STAFF REPORT
(One-Step Final Plat)

CASE NUMBER: SUB 2000-39 -- SCHRAFT 5TH ADDITION

SUB 2000-39 -- One-Step Final Plat of SCHRAFT 5TH ADDITION
June 8, 2000 - Page 2

VICINITY MAP

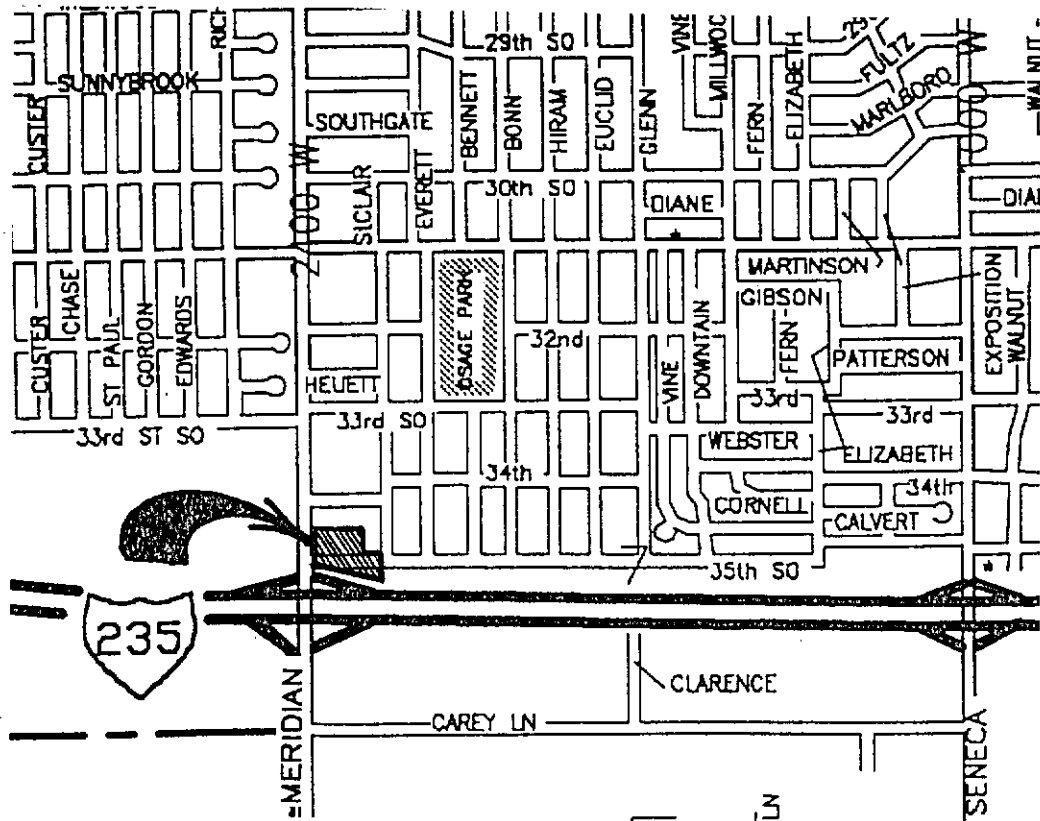
✓ FEMA
✓ drainage from Neighbor to the N & E
